604123-111717

ADDENDUM NO. 5

**Federal Aid Project Nos. CMQ-003S(390), STP-003S(390) & TAP-003S(390)
Roadway Reconstruction and Related Work along Route 126 (Pond Street)**

Transmitting revisions to the Contract Documents as follows:

**TYPICAL APPLICATION - SIDEWALK WORK
MIDBLOCK WITH TEMPORARY PEDESTRIAN PATH**

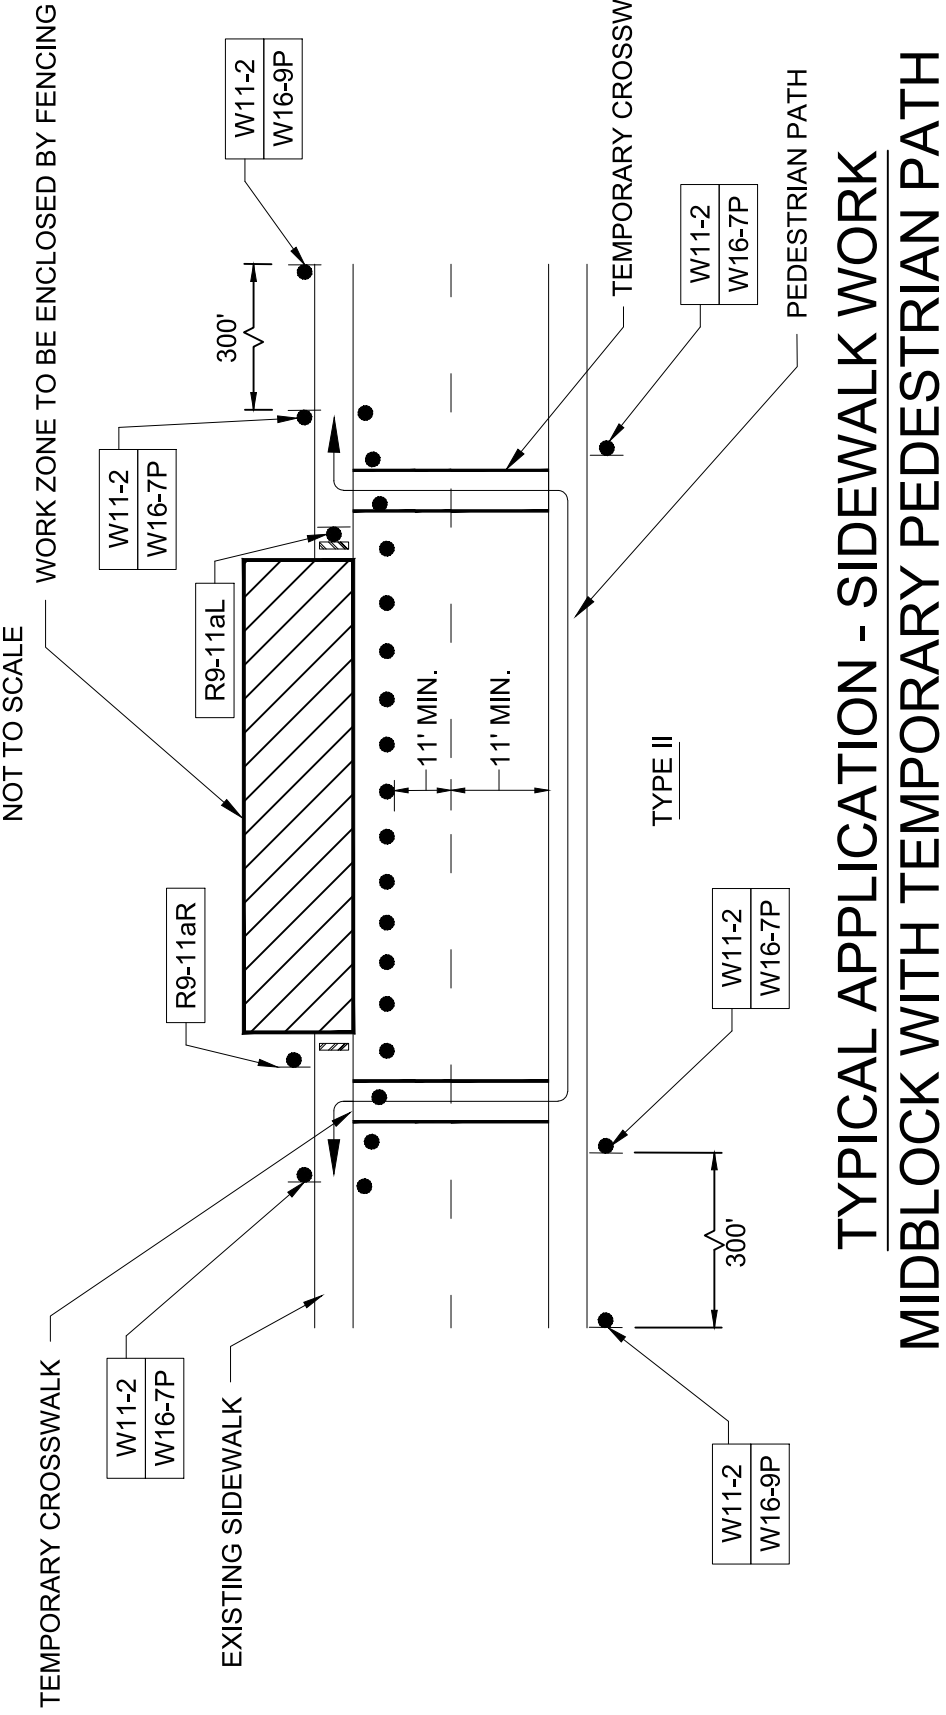
Question #23: Please provide a traffic management plan for the Spyglass retaining wall.

Response #23: The typical temporary two-lane road shoulder and/or travel lane closure application on Sheet 147 can be used as a temporary traffic management setup for the construction of the Spyglass retaining wall. See revised Sheet 147 of 331 for additional notes.

STATE	FED. AID PROJ. NO.	SHEET NO.	TOTAL SHEETS
MA	CMQ/TAP/STP-003S(390)	155	331
PROJECT FILE NO.			604123

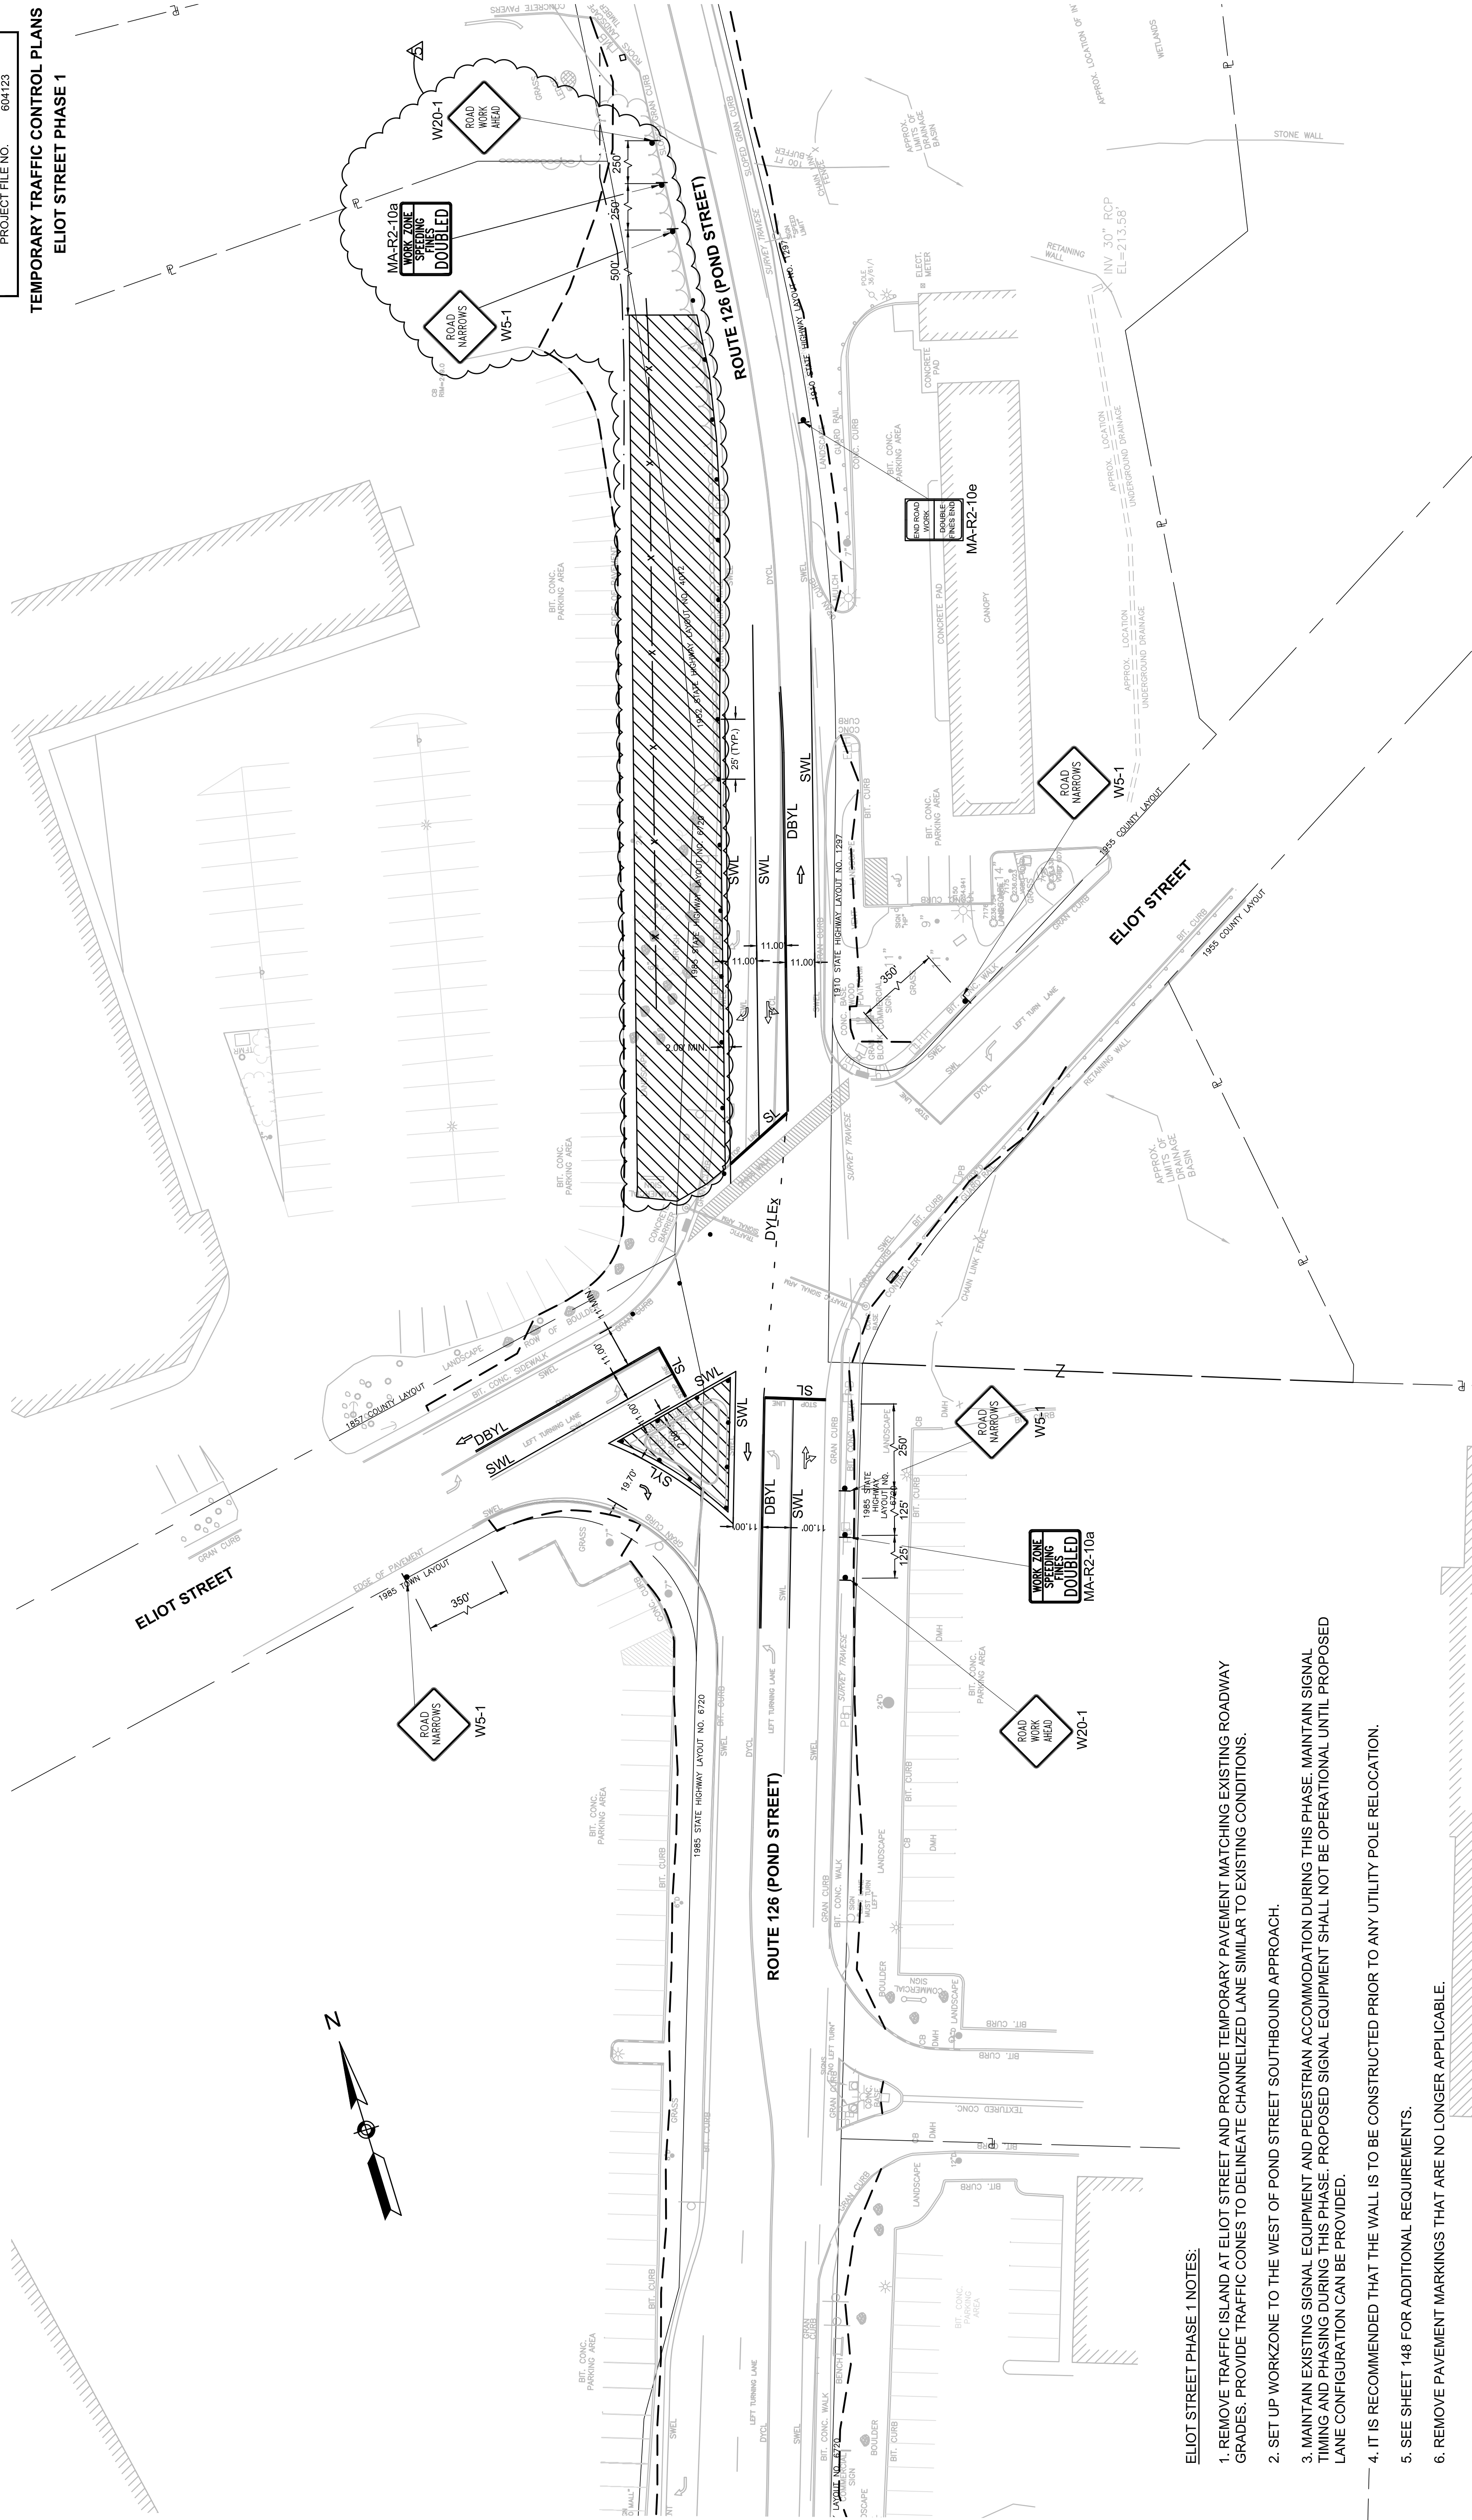
Question #19: Regarding traffic management plans the note on plan sheet 155 states it is recommended that the wall is to be constructed prior to any utility pole relocation. Please provide a temporary traffic control plan for the construction of the Eliot St. wall.

Response #19: The Phase 1 traffic management plan at Eliot Street/Pond Street intersection is intended to cover the temporary traffic control setup needed for the construction of the retaining wall, no additional site-specific temporary traffic control plans are needed. See revised sheets 155 and 159 of 331.
